**8903B-08**

# S E R V I C E N O T E

## 8903B Audio Analyzer

### **Motherboard Bumper Feet Deteriorate/Breakdown Over Time**

**Figure 1 – External Bottom Cover**

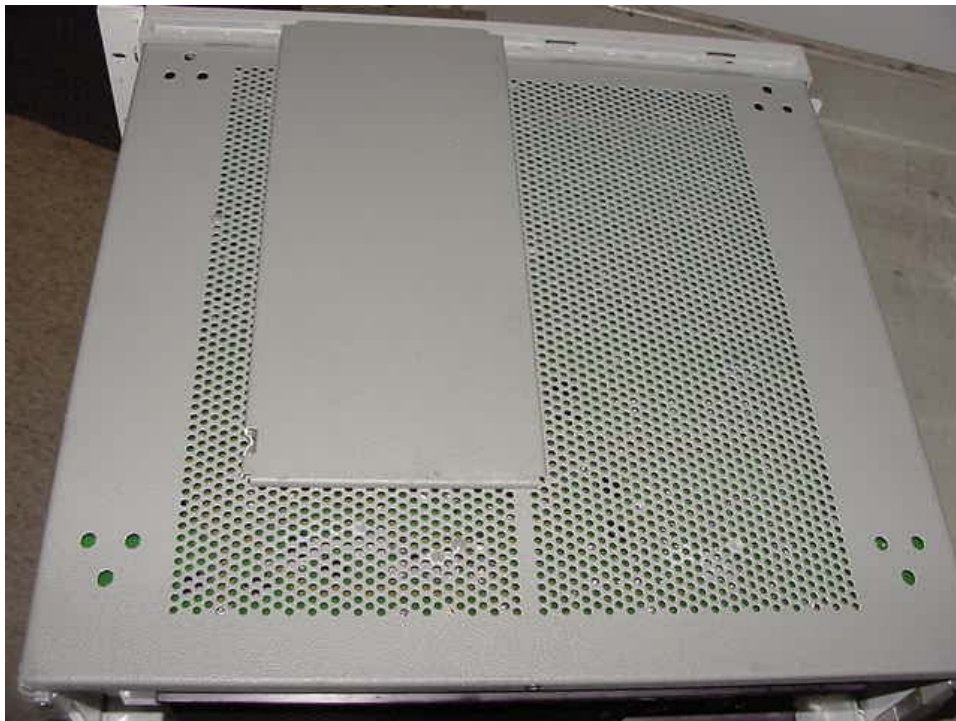
Inspect the motherboard bumper feet through the ventilation holes in the external bottom cover (Figure 1). Defective bumper feet can be identified by a melted appearance (Figure 2) or a 'goosey' residue (Figure 3) on surfaces or instruments underneath the Agilent 8903B.

Disconnect AC power from the instrument, remove the external bottom cover, identify and remove defective bumper feet, clean the surface and replace them with part number 0403-0285. Re-calibration is not required.

**Figure 2 – Defective Bumper Feet**

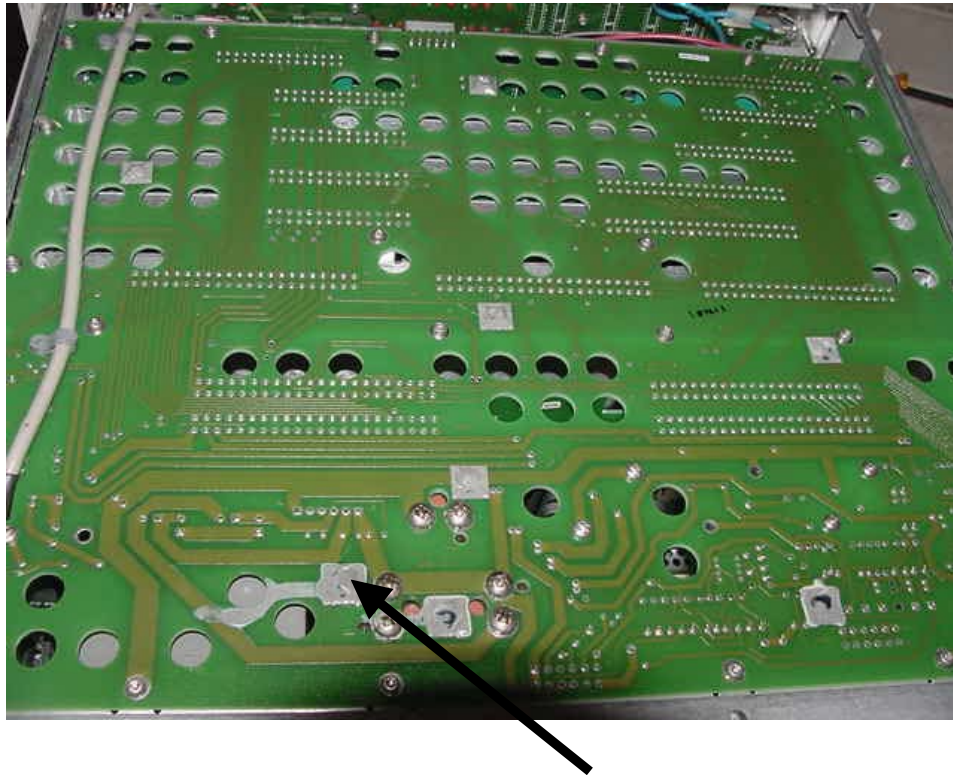
The motherboard bumper feet prevent contact between the bottom external cover and circuit traces on the motherboard. For instruments with serial prefixes noted above, these bumper feet may deteriorate or breakdown over a period of time.
